Government of the District of Columbia
Department of Transportation

MEMORANDUM

DATE: March 25, 2019

SUBJECT: ZC Case No. 06-10D – Art Place Block B

O:\PROJECTS\7501 - 8000\7611 ART PLACE PHASE II\PLANS\3.13.19 AUTOTURNS\C&A ART PLACE AUTOTURNS.DWG

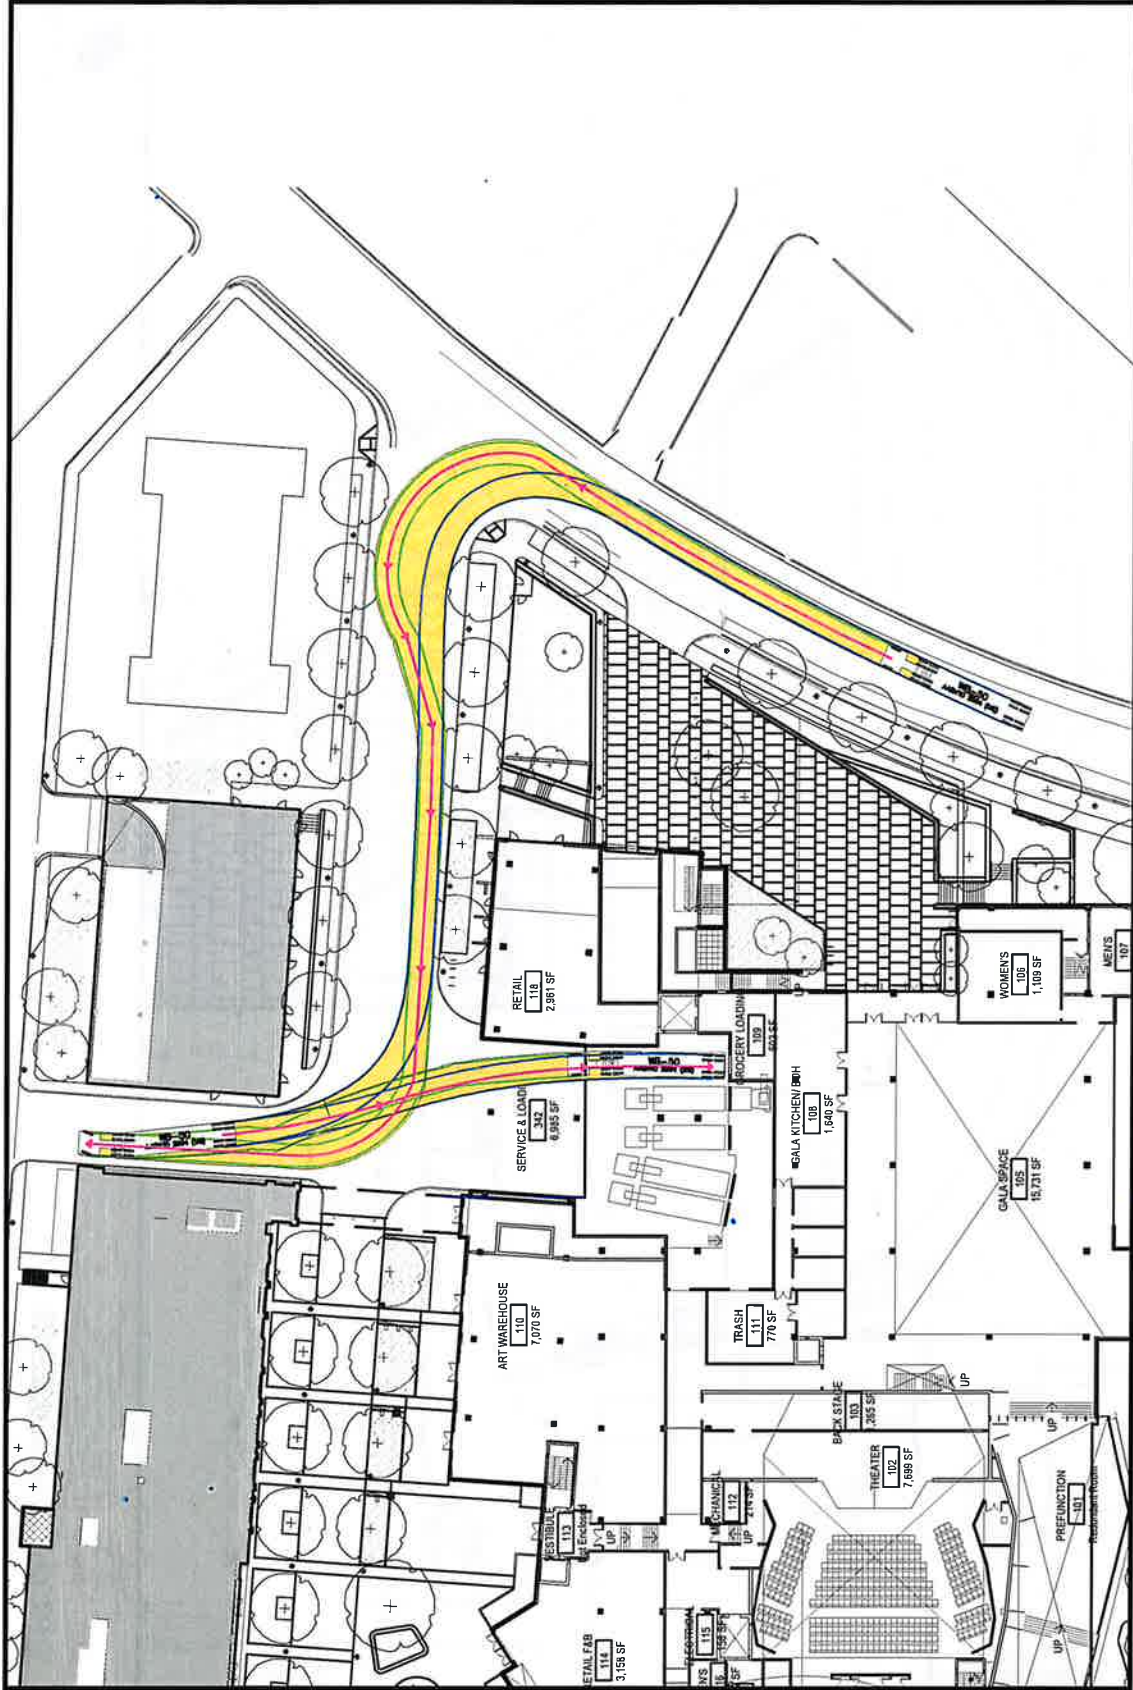
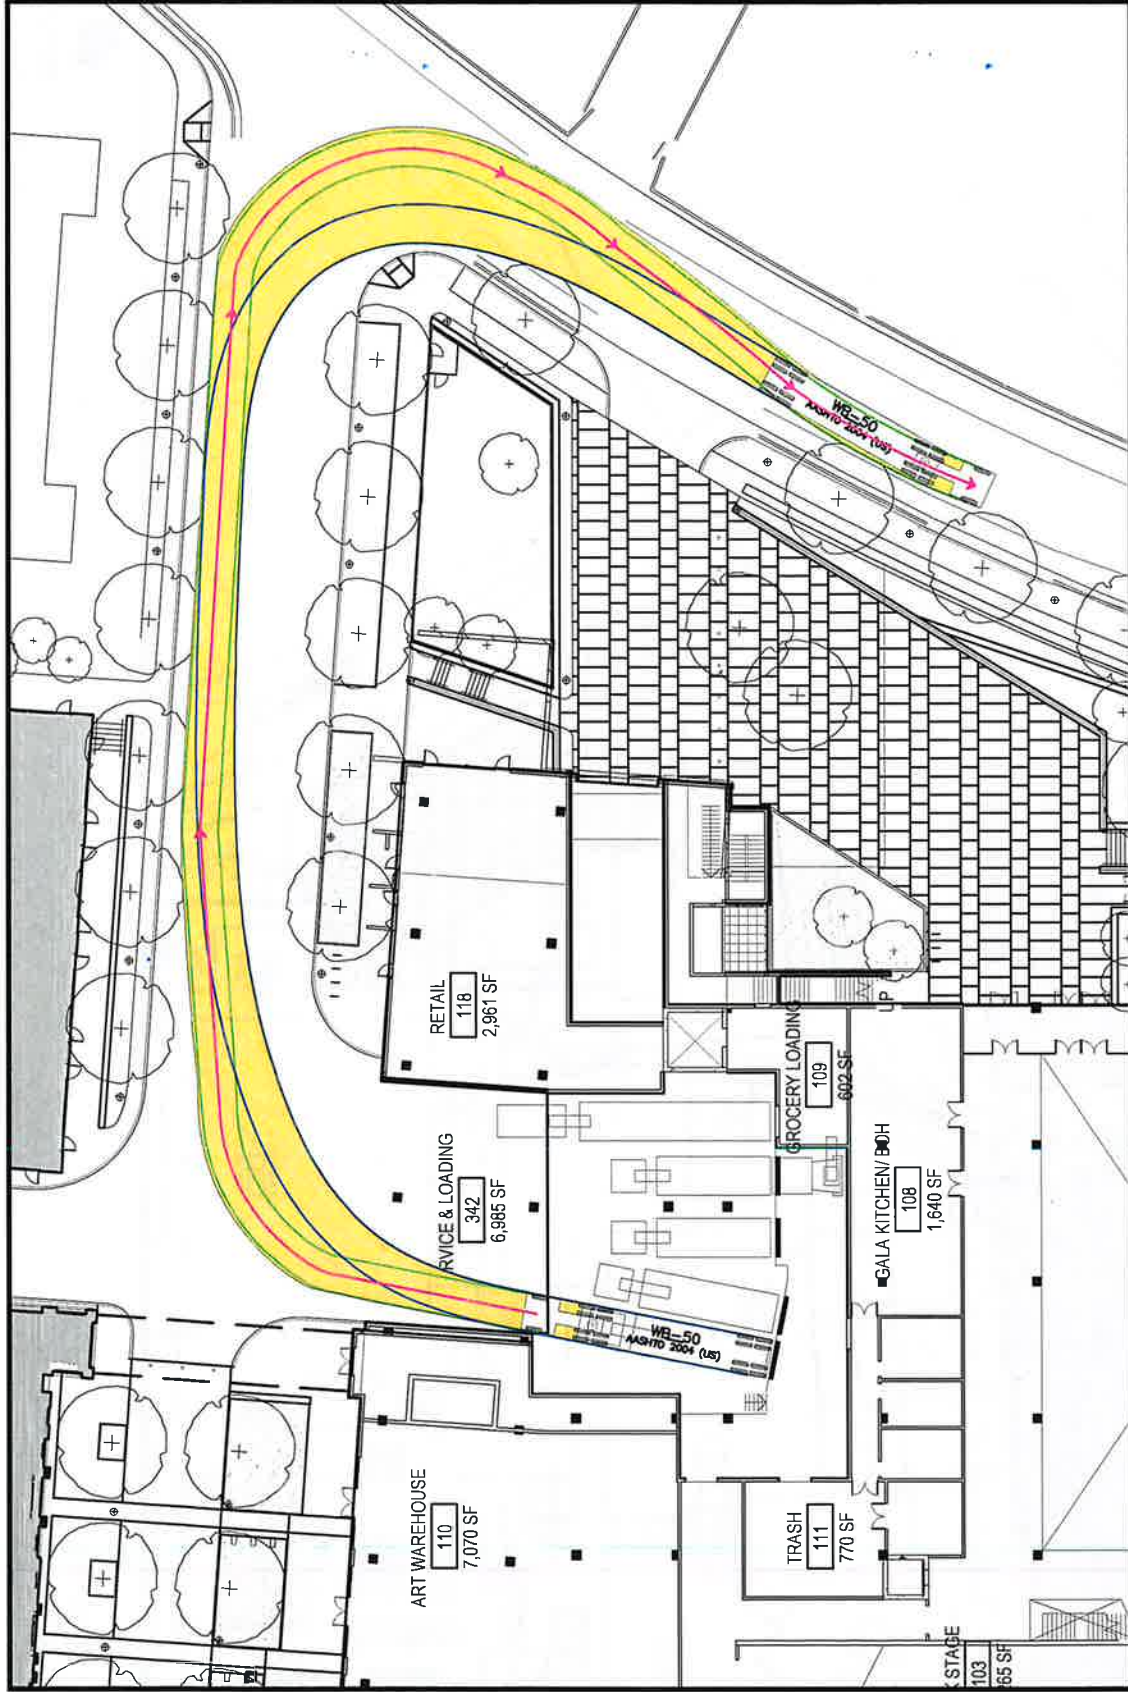
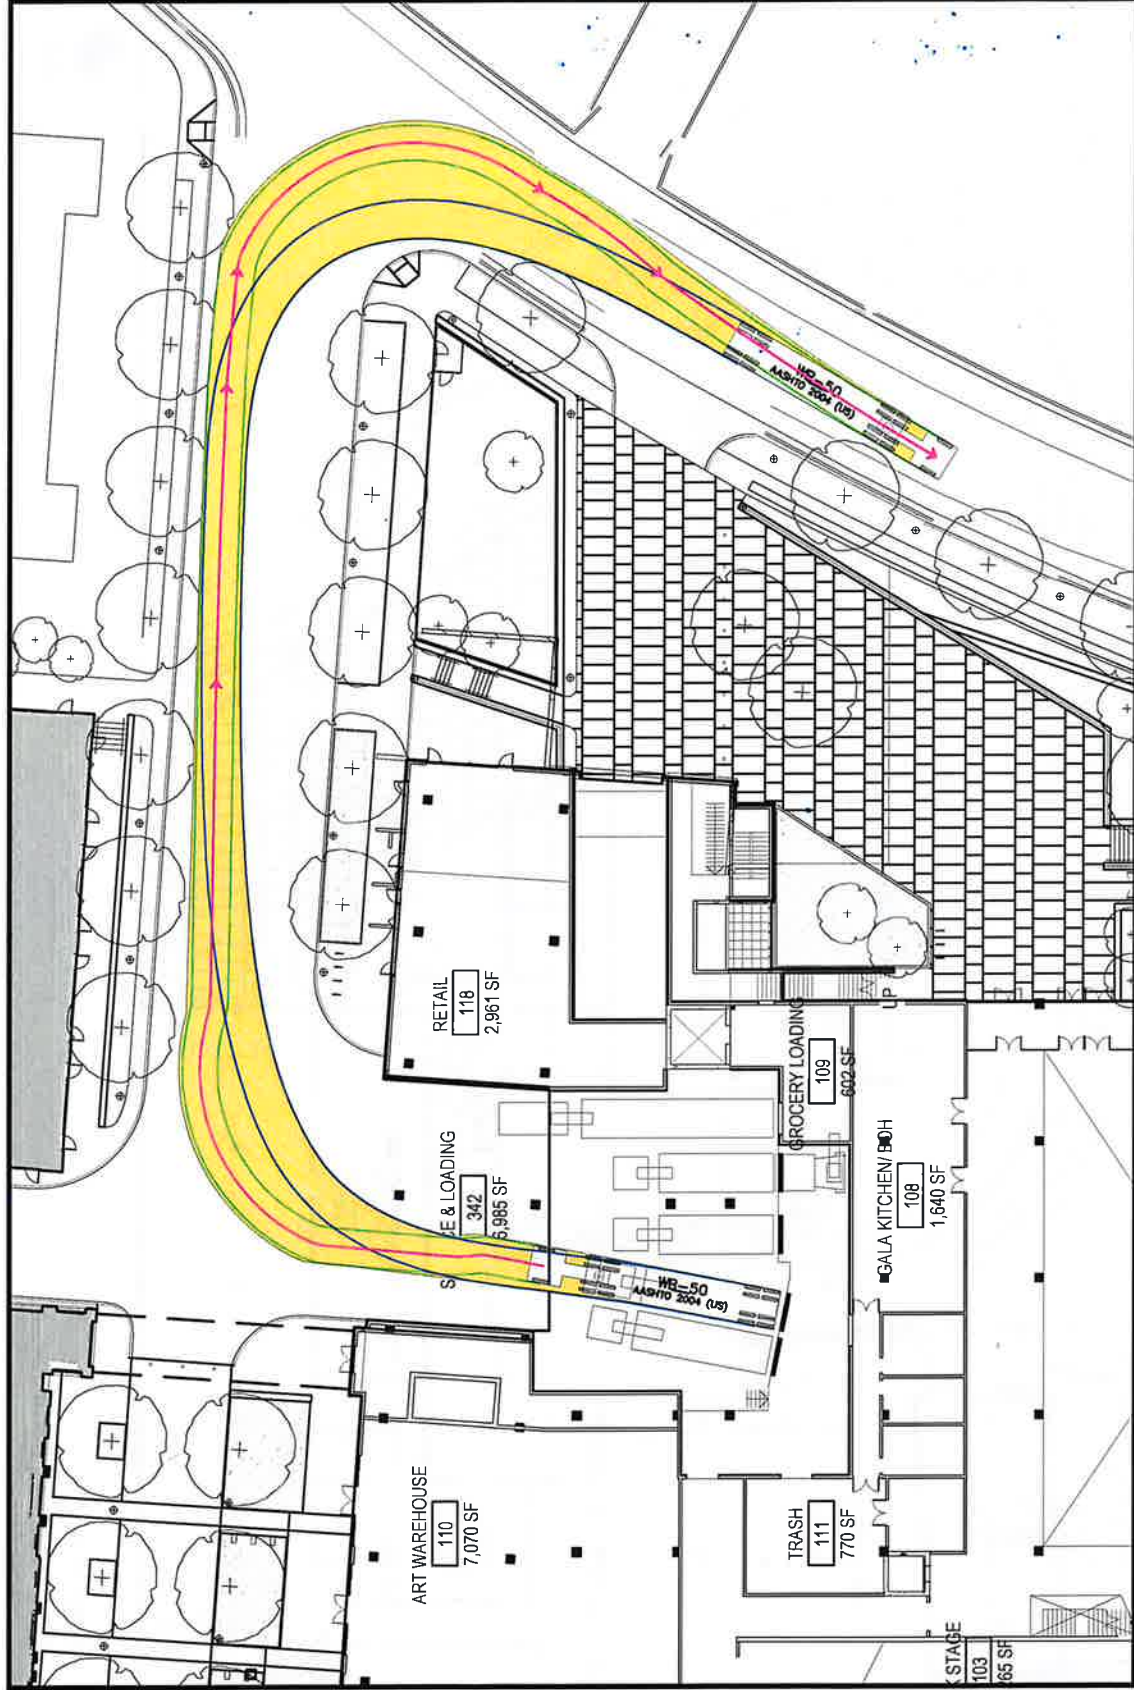
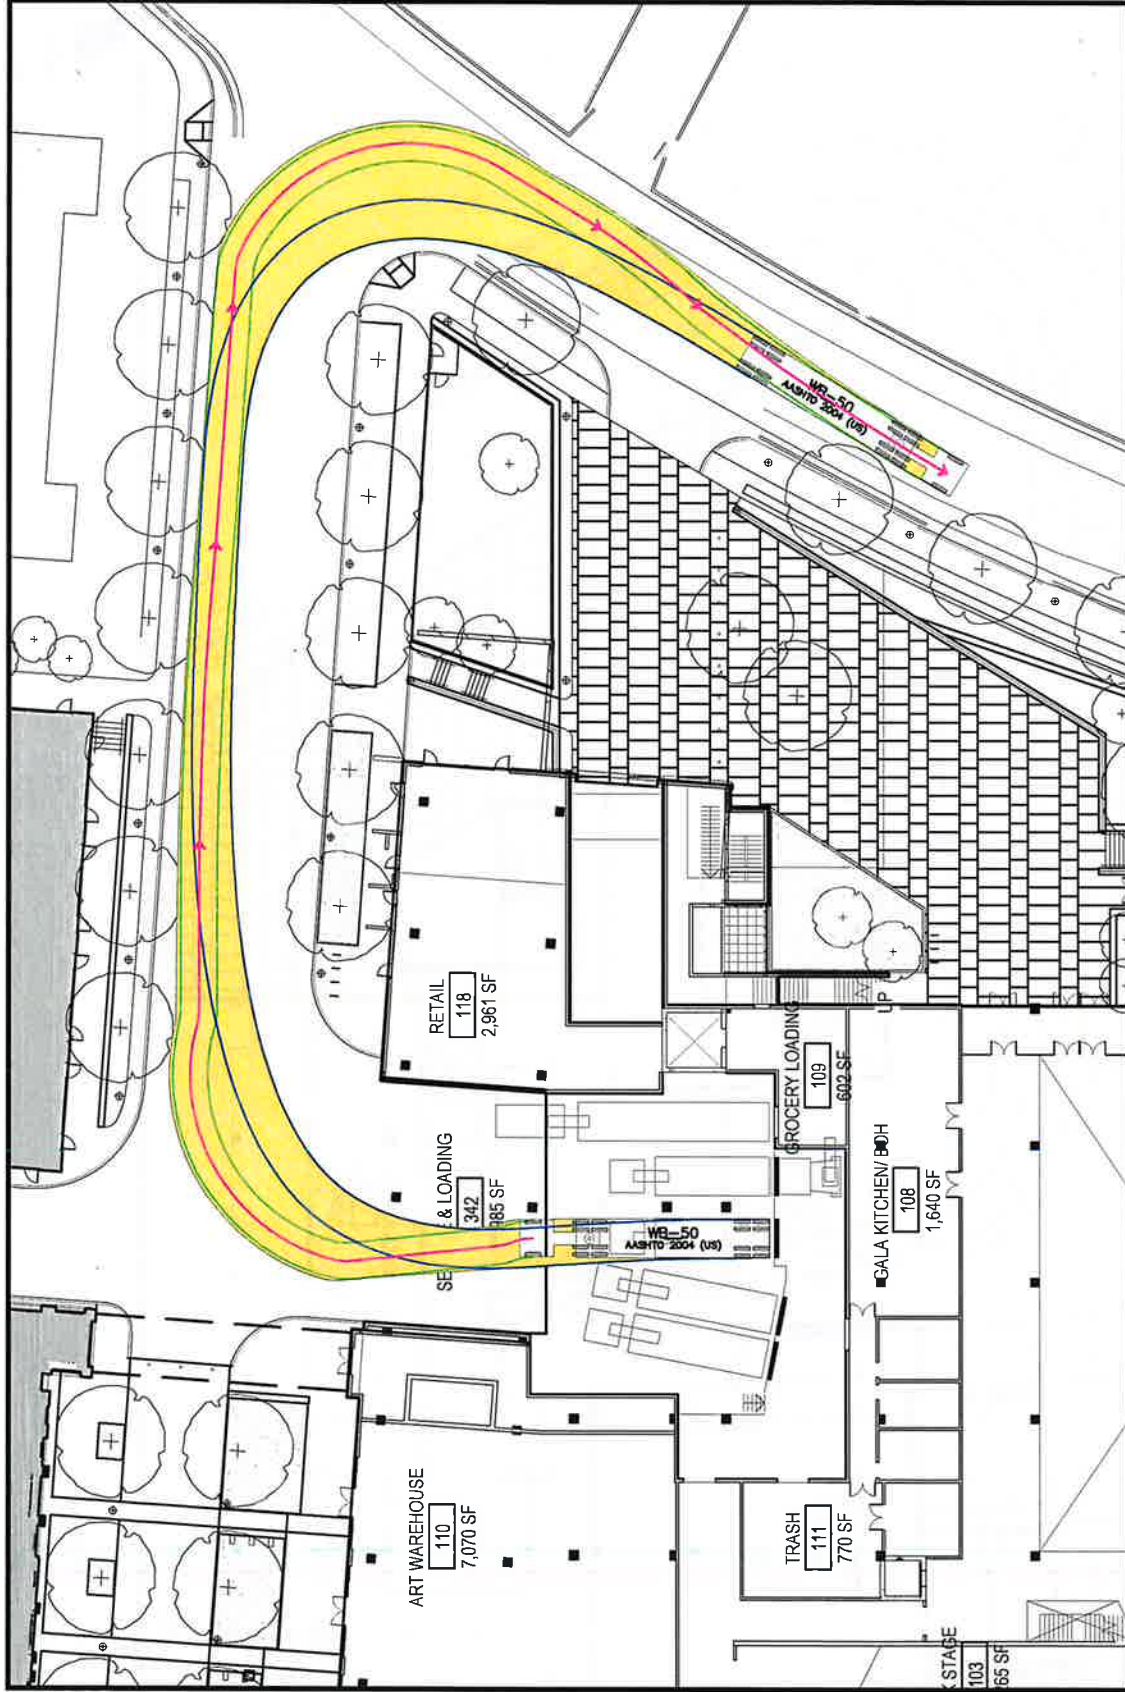
Comment #6: *In Appendix I, there are several instances of trucks clipping corners and going over curbs, even on the private street. Also, since Kennedy Street will be realigned in the future, the analysis should be done with that future alignment. On page I-12, you'd need to restrict parking on Kennedy to make the turn, so you'll need to discuss in your analysis how and when that parking would be restricted.*

Response: Updated swept area diagrams are provided in Attachment 2. The truck size for the site has been reduced to SU-50 for the commercial uses in the eastern building and SU-30 for the residential uses in the western building. A revised Loading Management Plan is included as Attachment 3. Loading for the western building via the public alley would no longer encroach on the parking area on Kennedy Street prior to entering the alley.

The Kennedy Street alignment has not yet been fully designed; therefore, it would be difficult to provide detailed truck turning diagrams on the future alignment. At the time that the realigned roadway is designed, trucks will be accommodated with appropriate curb radii and roadway widths.
